# Access Compliance Report

## Public Rights-of-Way

### (Pedestrian Signals)

Intersection ID: N/A	Main Street:	Cross Street: N/A	Location: N/A
ADA ID: 656470611966	Signal Type: One Push Button-APS	Overall Compliance: No	Severity Score: BTN 1: N/A BTN 2: N/A No BTN: N/A
Codes/Mitigation Info/Possible Solution		Field Measurements/Component Compliance

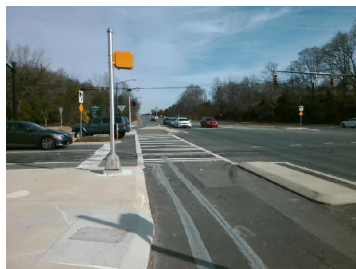
PROW/ADA: R209.1, TMUTCD 4e.08, R404.2, R404.3, R404.7.3, R404.7.2

Possible Solutions: Install Sign. Remove and Replace Clear Space.
